HISTORIC AND DESIGN REVIEW COMMISSION

HDRC CASE NO: 2024-002
ADDRESS: 122 E HOUSTON ST
LEGAL DESCRIPTION: NCB 106 (SAVOY BUILDING), LOT 41
ZONING: D, H, RIO-3
CITY COUNCIL DIST.: 1
DISTRICT: Main/Military Plaza Historic District
APPLICANT: Jennifer Gribble/INSITE
OWNER: Katherine Fontenot/CABBAGE LTD
TYPE OF WORK: Storefront modifications, canopy installation
APPLICATION RECEIVED: January 02, 2024
60-DAY REVIEW: March 02, 2024
CASE MANAGER: Edward Hall

SAVOY BUILDING

H-1

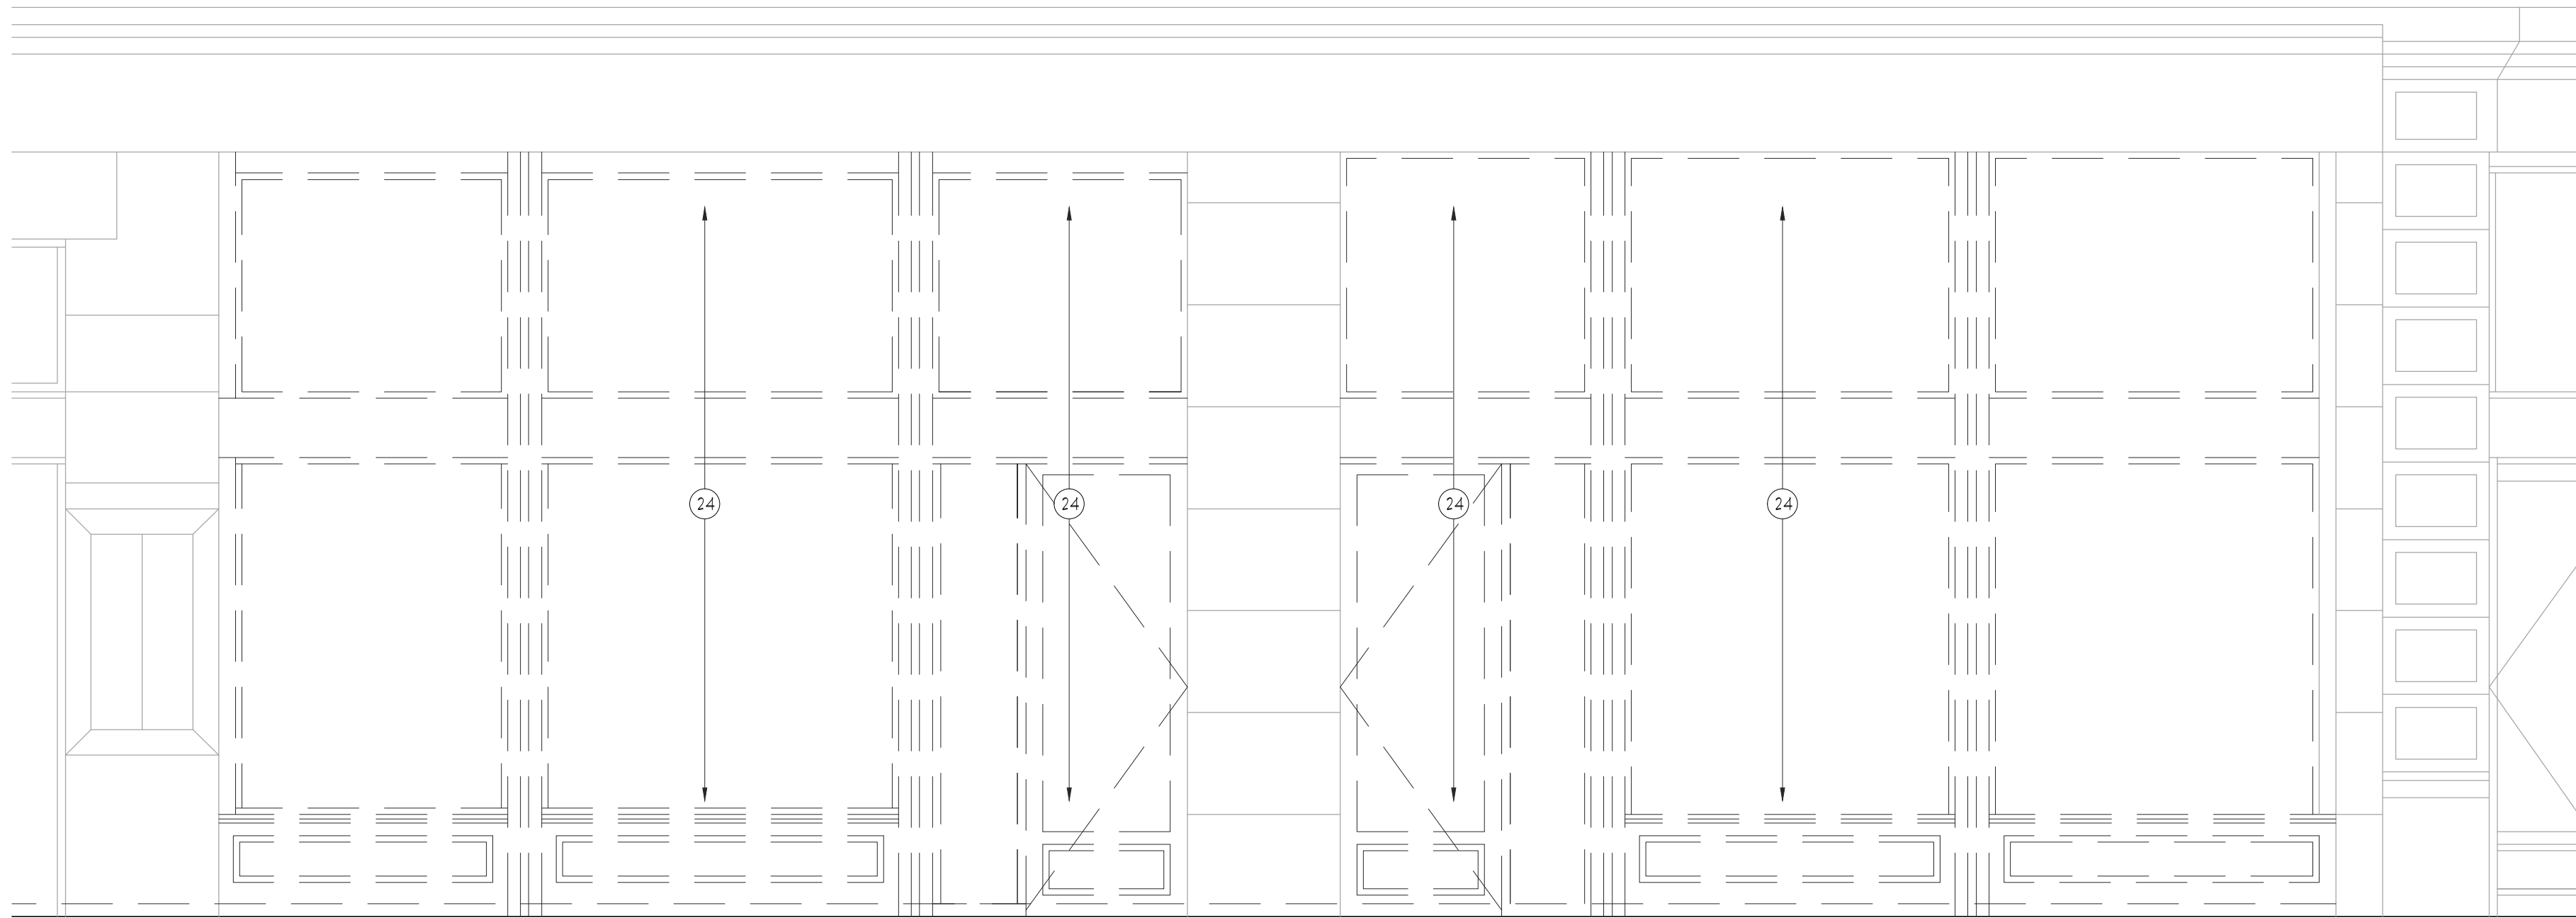
- b. STOREFRONT MODIFICATION – The applicant has proposed to modify the existing, non-original storefront system by relocating two (2) pedestrian entrance doors from their current locations to locations to the far east and west of the storefront openings to meet life safety codes and egress requirements. Both doors will maintain a recess as currently exists and the applicant has noted that the existing storefront elements will be reused, where possible. Generally, staff finds the proposed storefront modifications to be appropriate. All new materials should match the existing in material and profile. All historic entrance and floor tile should be preserved.

- 1. Staff recommends approval of item #1, modifications to the existing storefront system based on findings a and b with the following stipulations:
 - i. That all existing storefront system elements be reused to the greatest extent possible and that any new storefront elements match the existing in profile and material.
 - ii. That all existing floor tile and entrance tile work be preserved.
- 2. Staff recommends approval of item #2, canopy installation, based on findings a and c with the following stipulations:
 - i. That a canopy that matches the previously installed canopy should be installed to provide continuity in the building façade and to be complementary of the original canopy, which spanned the entire façade.

H-2

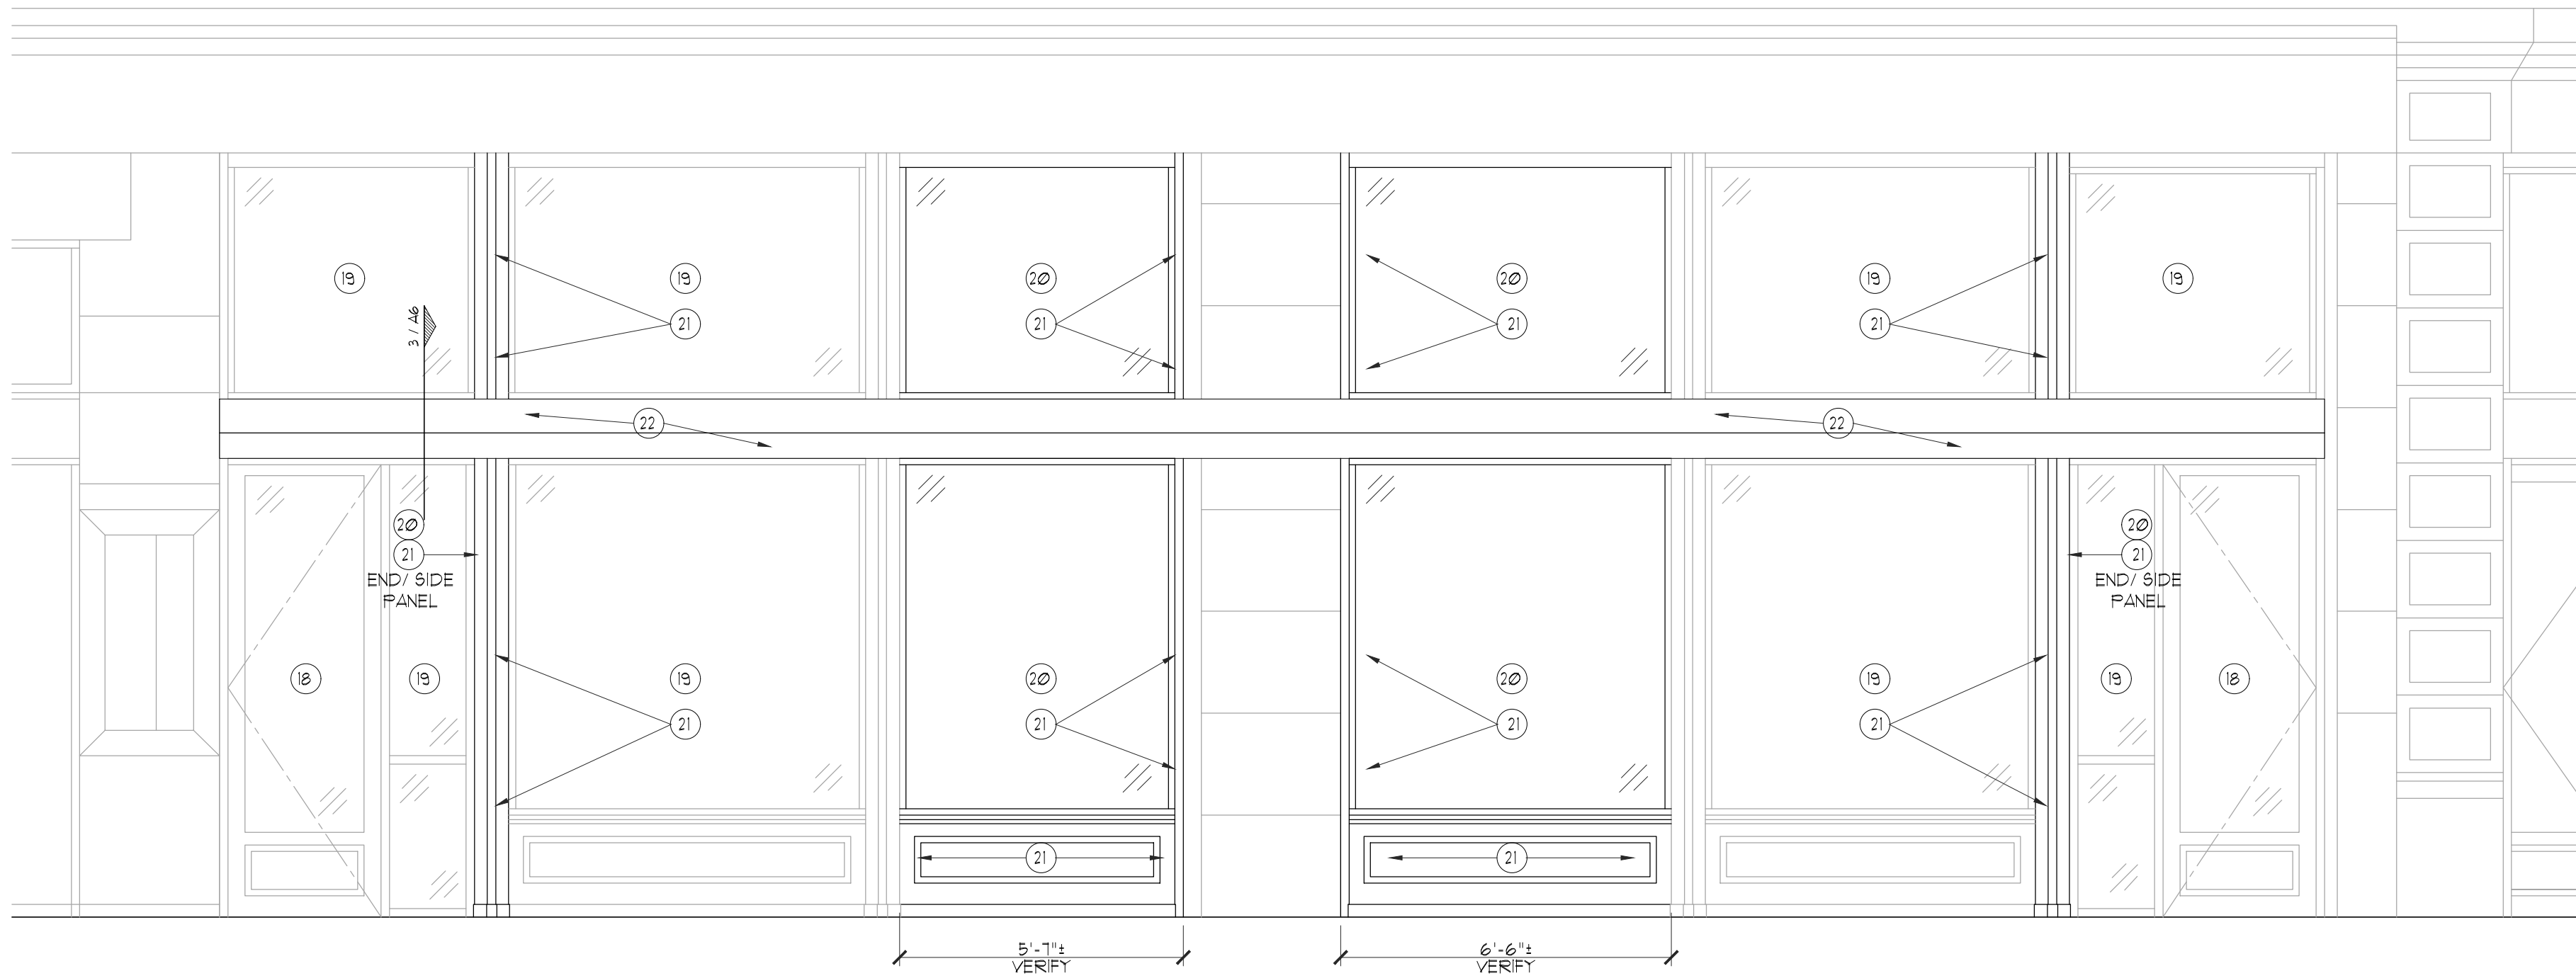
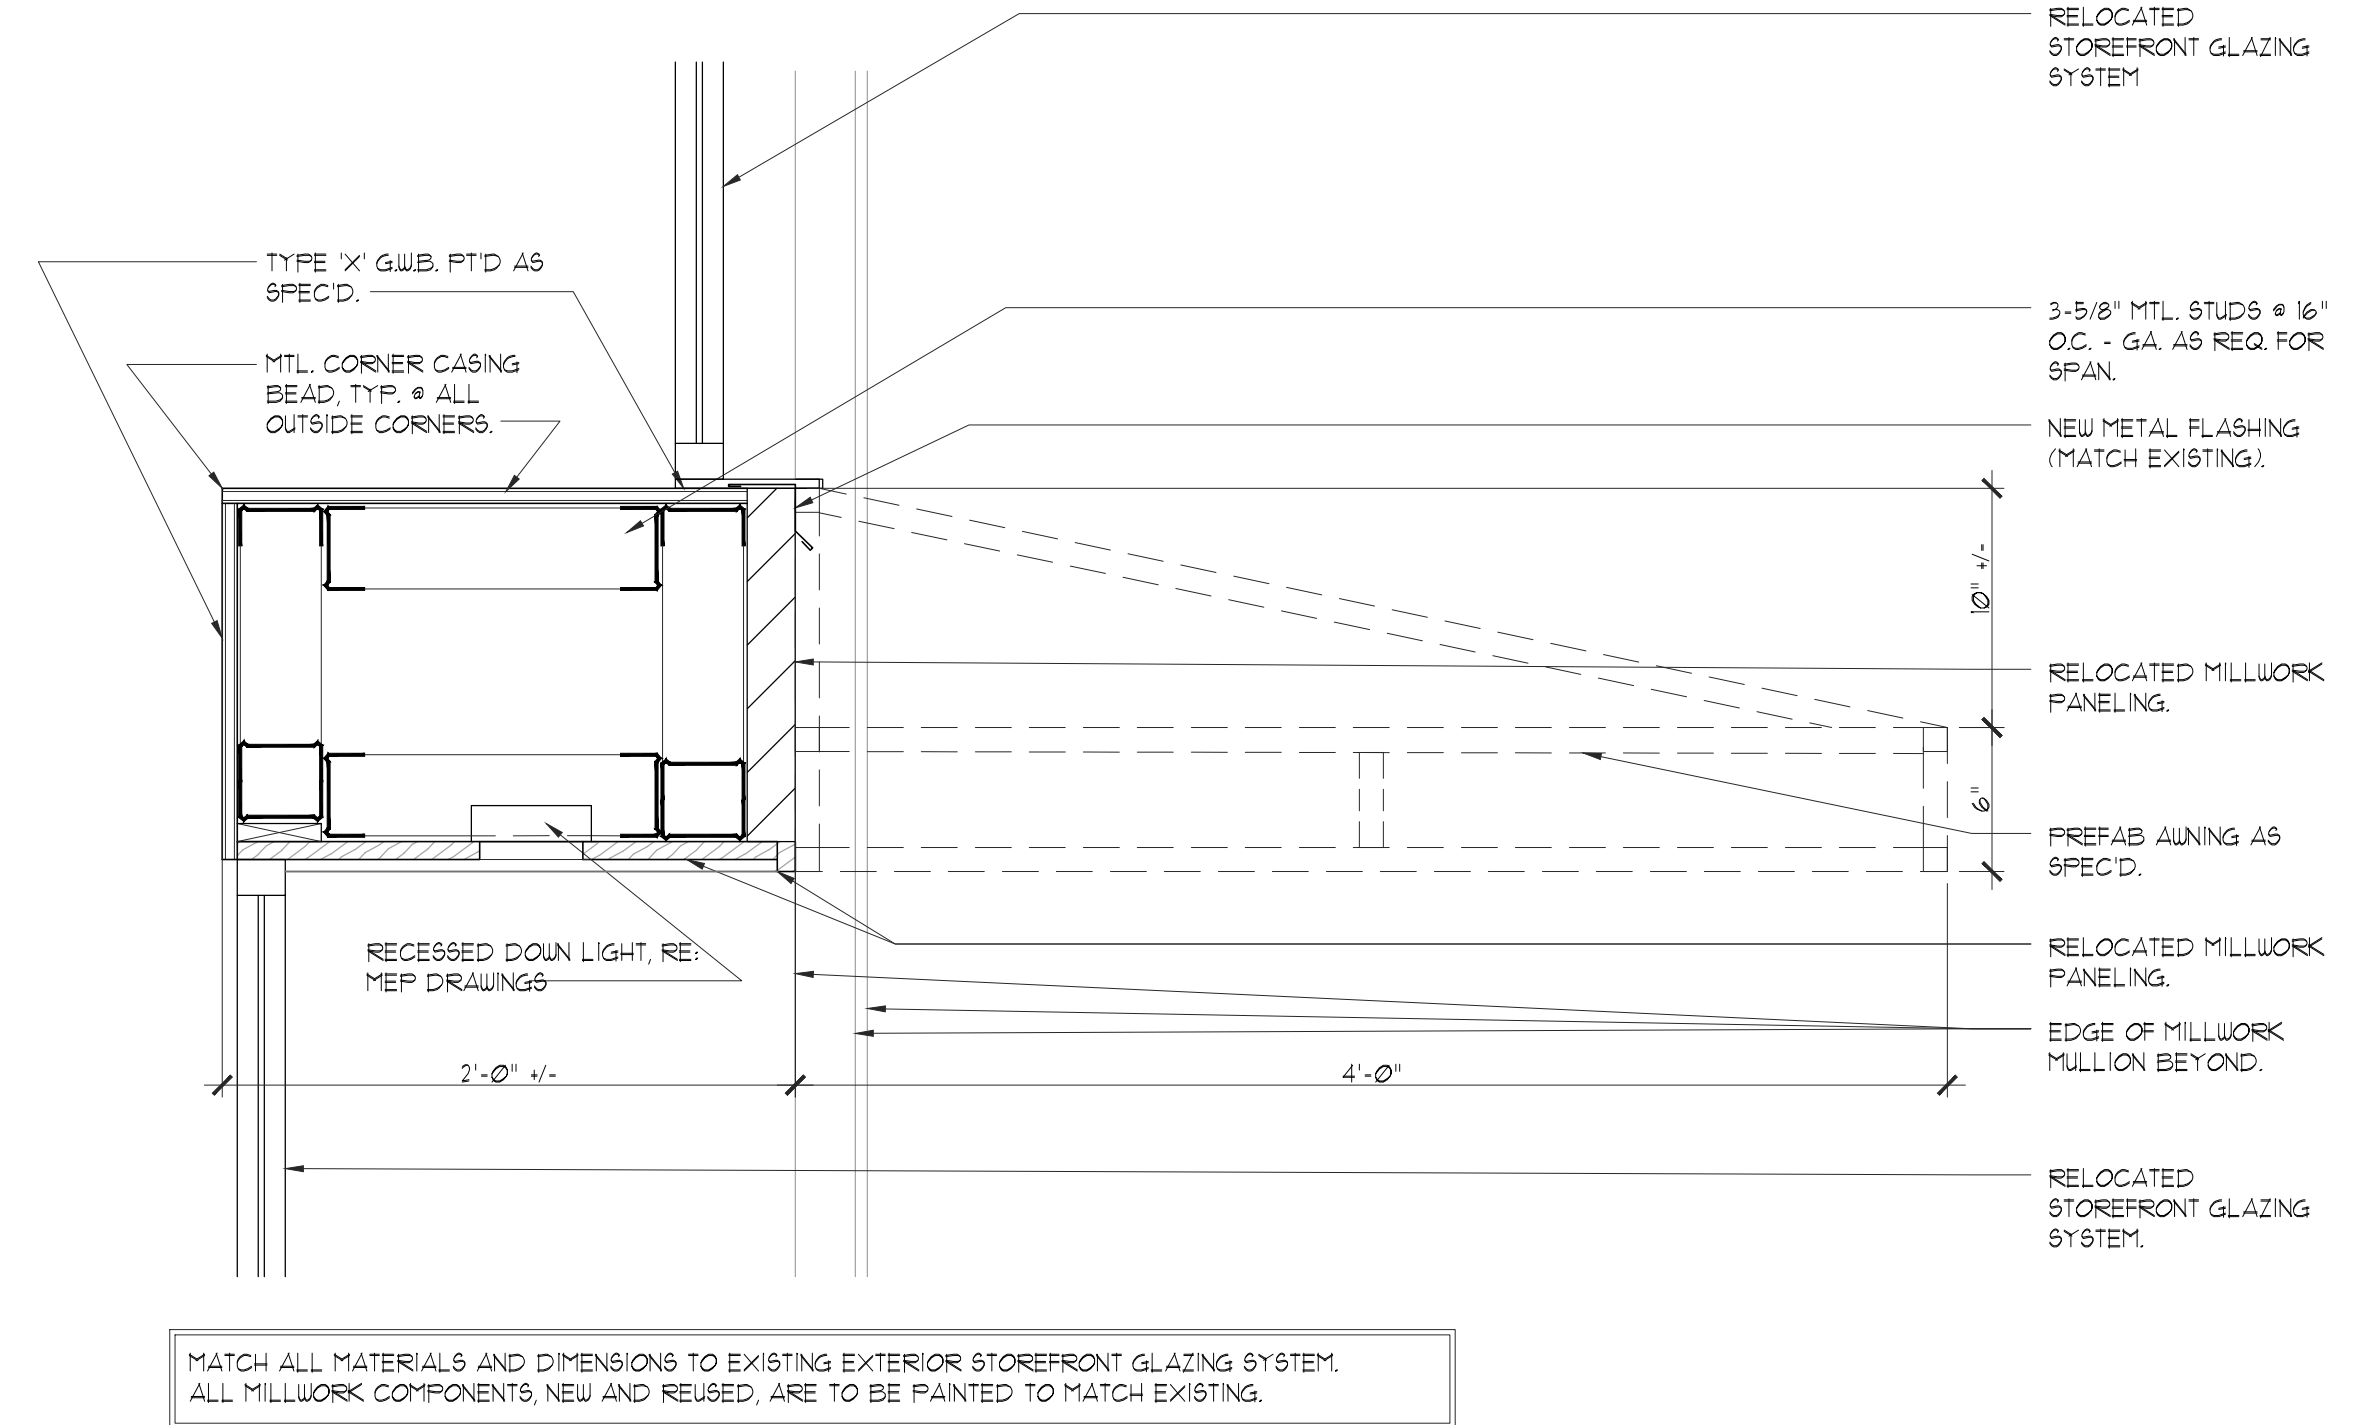
- c. CANOPY INSTALLATION – Above the storefront, the applicant has proposed install a fabric clad aluminum canopy to span the length of the storefront. The Guidelines for Exterior Maintenance and Alterations 11.B.ii. notes that canopy and awnings should be based on accurate evidence of the original, such a photographs. If no such evidence exists, the design of new canopies and awnings should be based on the architectural style of the building and be proportionate in shape and size to the scale of the façade to which they will be attached. Staff finds that a canopy that matches the previously installed canopy should be installed to provide continuity in the building façade and to be complementary of the original canopy, which spanned the entire façade.
